Revise the Beaver Valley Power Station, Unit No. 1  
Proposed Technical Specification Change No. 183.

### Beaver Valley Power Station, Unit No. 1 Proposed Technical Specification Change No. 183 REVISION OF TECHNICAL SPECIFICATIONS 3.6.1.4 AND 3.6.2.2

#### A. DESCRIPTION OF AMENDMENT REQUEST

FIGURE 3.6-1  
MAXIMUM ALLOWABLE PRIMARY CONTAINMENT AIR PRESSURE  
VERSUS RIVER WATER TEMPERATURE

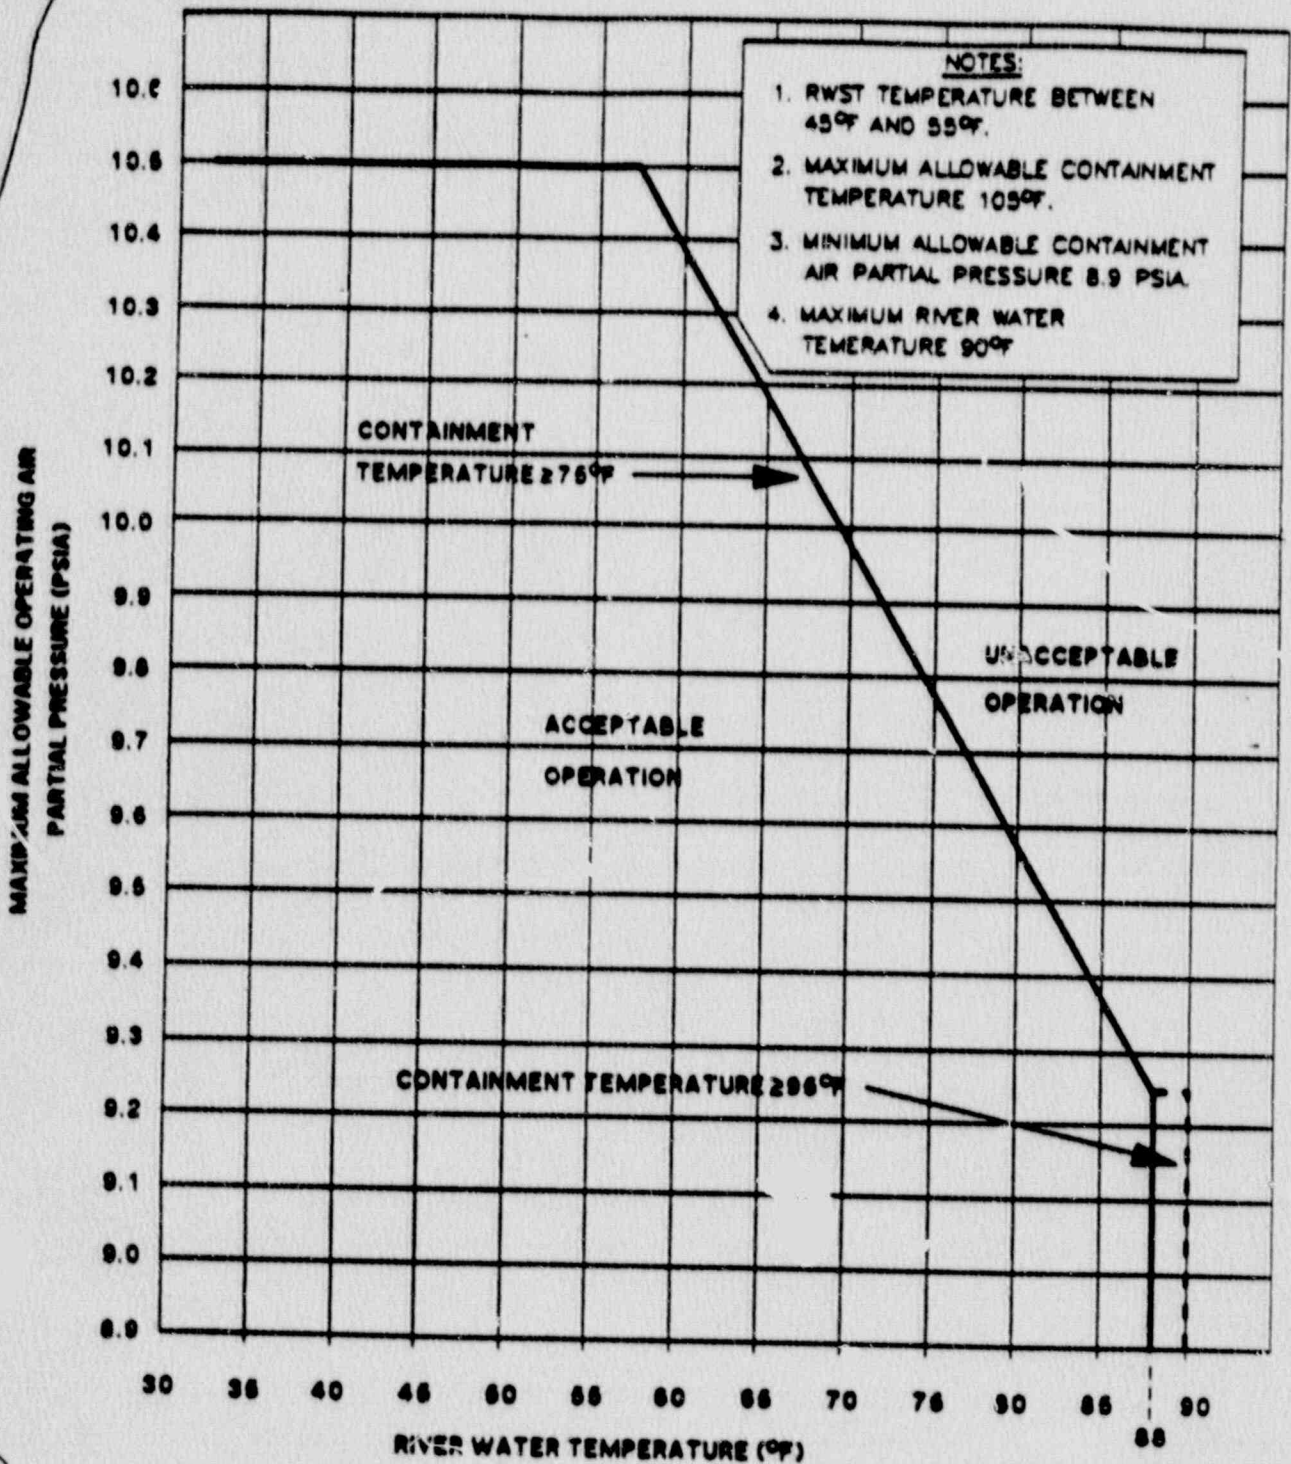
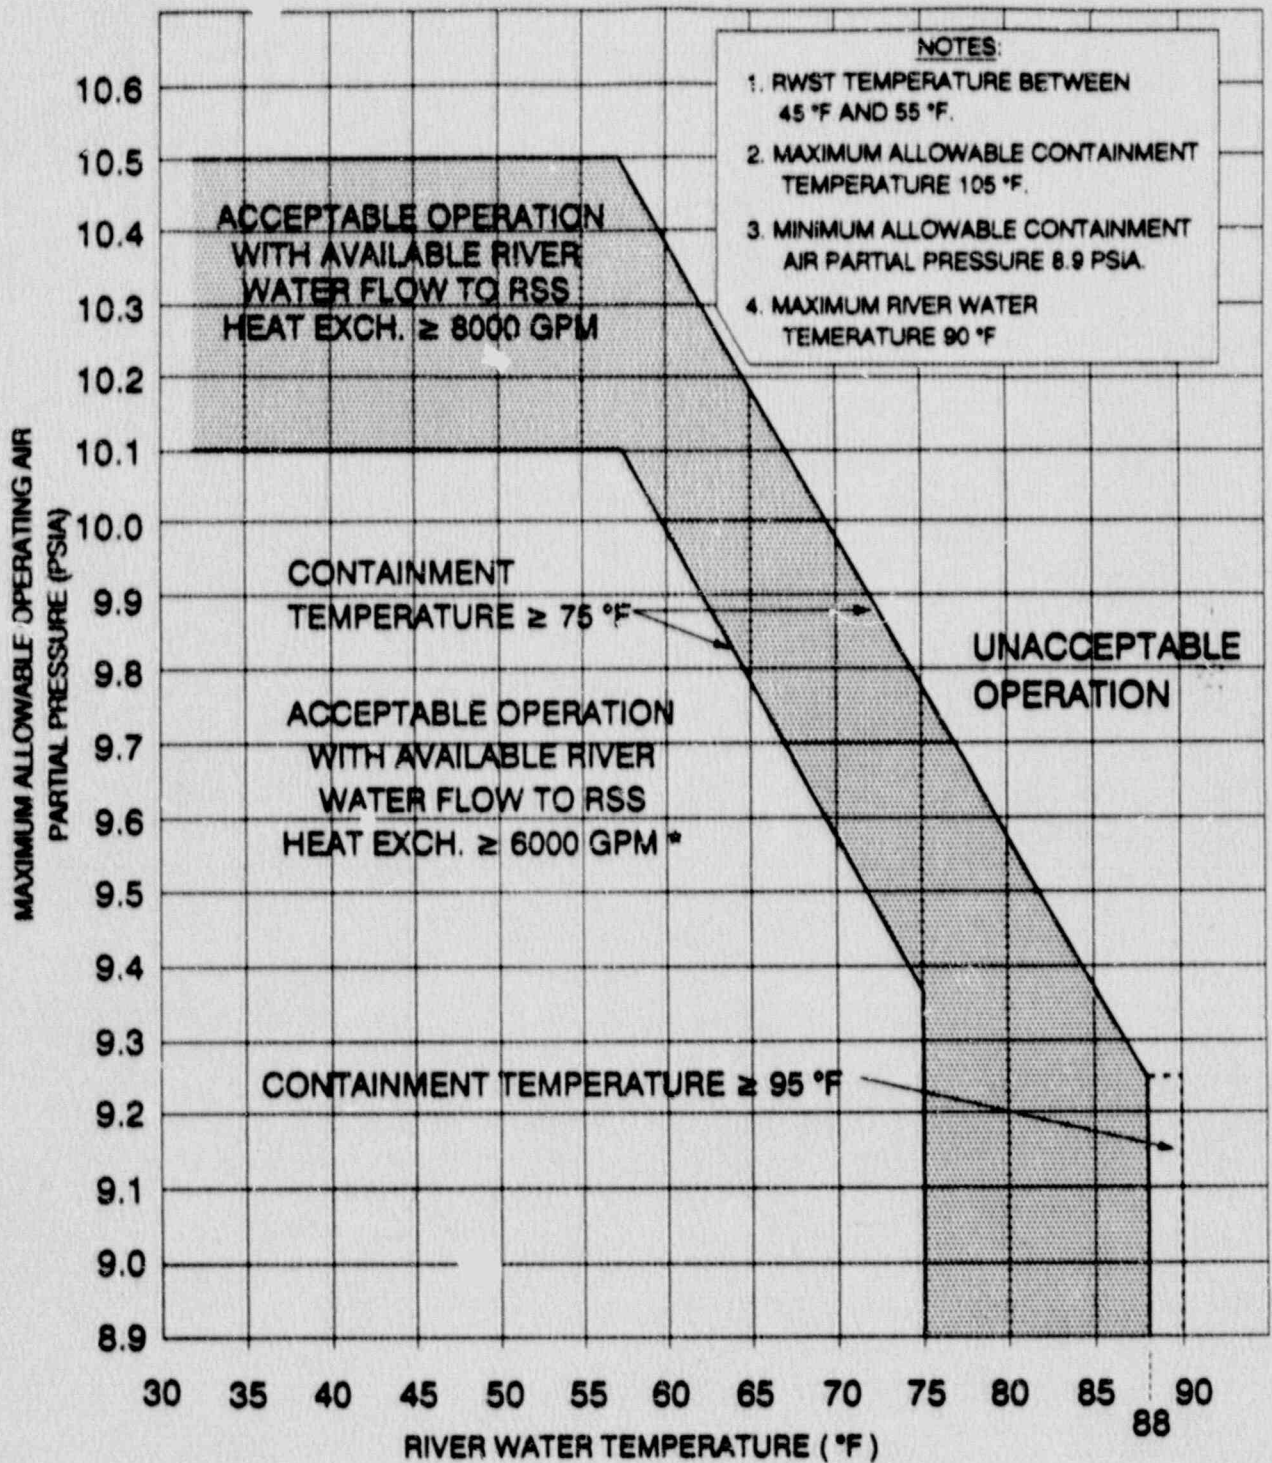
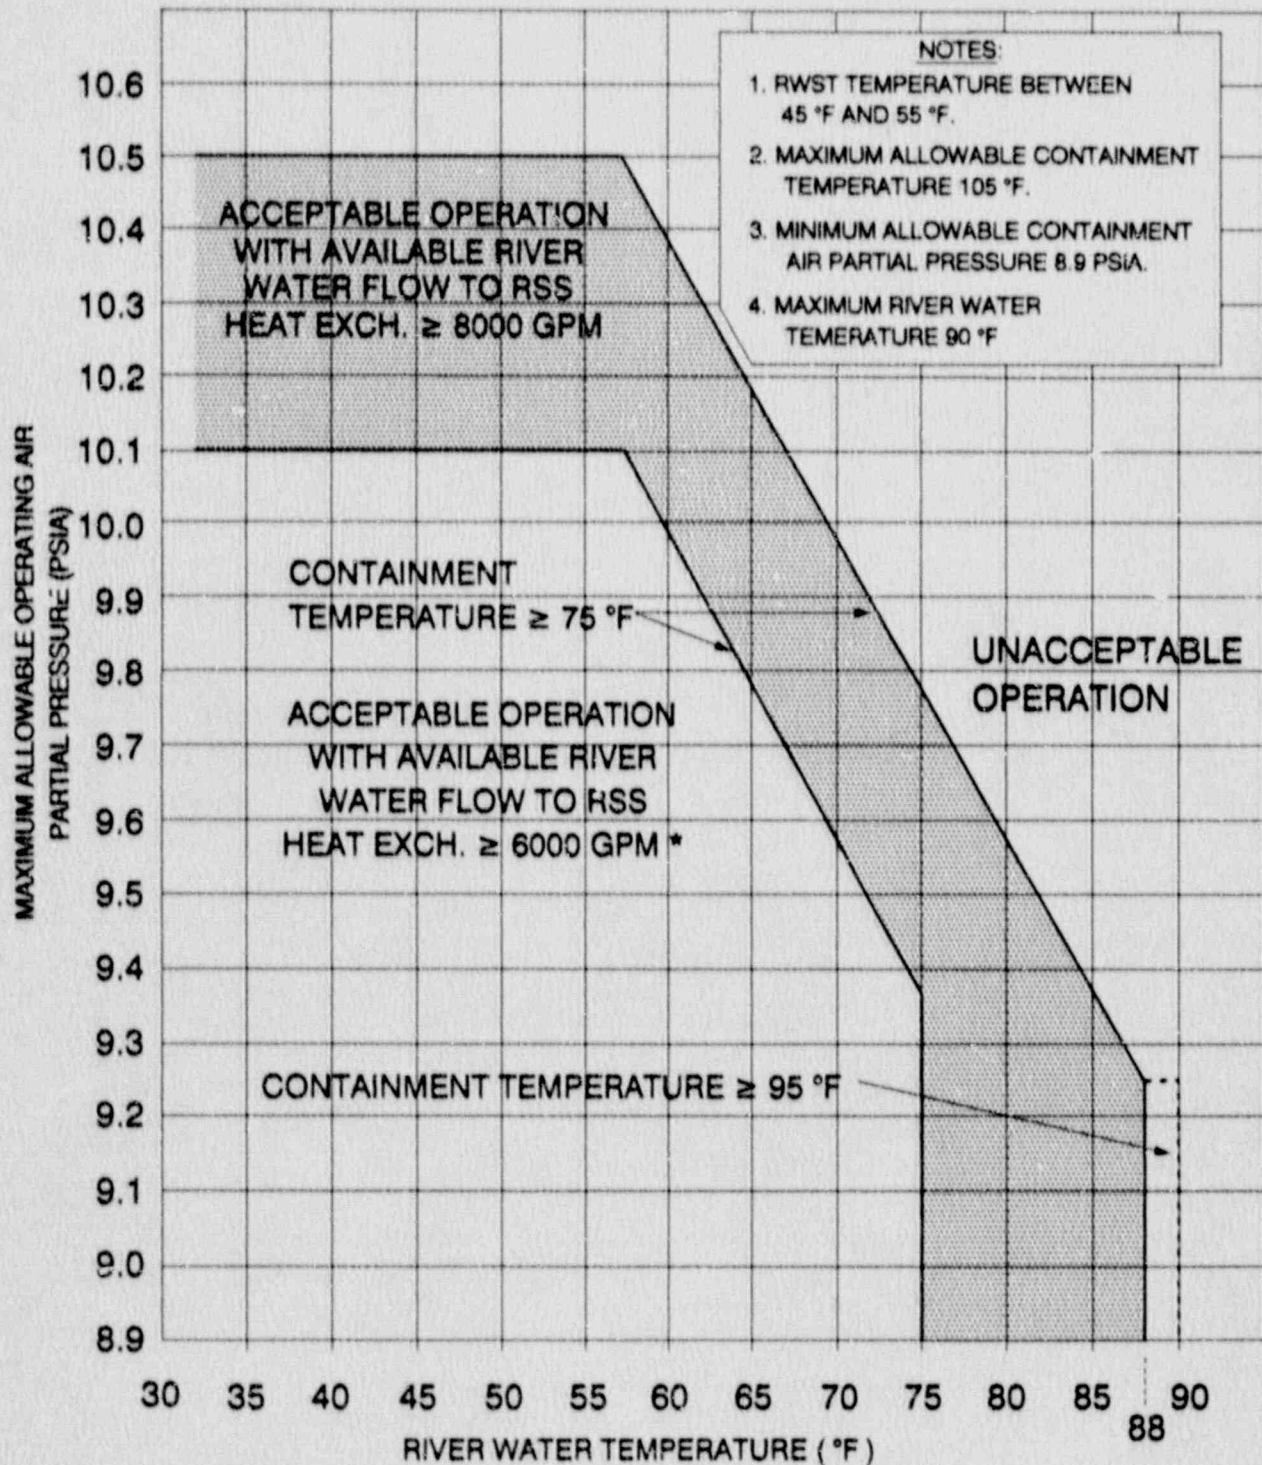
3.6.1.4 Primary Containment internal air partial pressure shall be maintained  $\geq$  8.9 PSIA and within the acceptable operation range (below and to the left of the applicable containment temperature limit ~~line~~) shown on Figure 3.6-1 as a function of river water temperature.

With the containment internal air partial pressure  $<$  8.9 PSIA or above the applicable containment temperature limit ~~line~~ shown on Figure 3.6-1, restore the internal pressure to within the limits within 1 hour or be in at least HOT STANDBY within the next 6 hours and in COLD SHUTDOWN within the following 30 hours.

REPLACE WITH  
INSERT "A"

\* The 6000 GPM is applicable until the eighth refueling outage (8R) only and then reverts to 8000 GPM following 8R.

This approach led to the conclusions that the depressurization time analysis was the limiting analysis for the river water temperature range of interest and that the operating limit which is most sensitive to changes in heat removal capability is the containment air partial pressure. This limit is shown on Proposed Technical Specification Figure 3.6-1. The development of this curve essentially maximizes the allowable air partial pressure by taking advantage of the increased heat removal provided at lower river water temperatures. Therefore, lowering the limit reduces the heat removal requirement and allows reduced flow. LOCTIC runs were performed to determine the new limits which provided acceptable results at reduced river water flow of 6000 gpm per train. The results are shown as a new limit on Proposed Figure 3.6-1 and in Table 2.

3.6.1.4 Primary Containment internal air partial pressure shall be maintained  $\geq 8.9$  PSIA and within the acceptable operation range (below and to the left of the applicable containment temperature limit line(s)) shown on Figure 3.6-1 as a function of river water temperature.

With the containment internal air partial pressure  $< 8.9$  PSIA or above the applicable containment temperature limit line(s) shown on Figure 3.6-1, restore the internal pressure to within the limits within 1 hour or be in at least HOT STANDBY within the next 6 hours and in COLD SHUTDOWN within the following 30 hours.

\* The 6000 GPM is applicable until the eighth refueling outage (8R) only and then reverts to 8000 GPM following 8R.
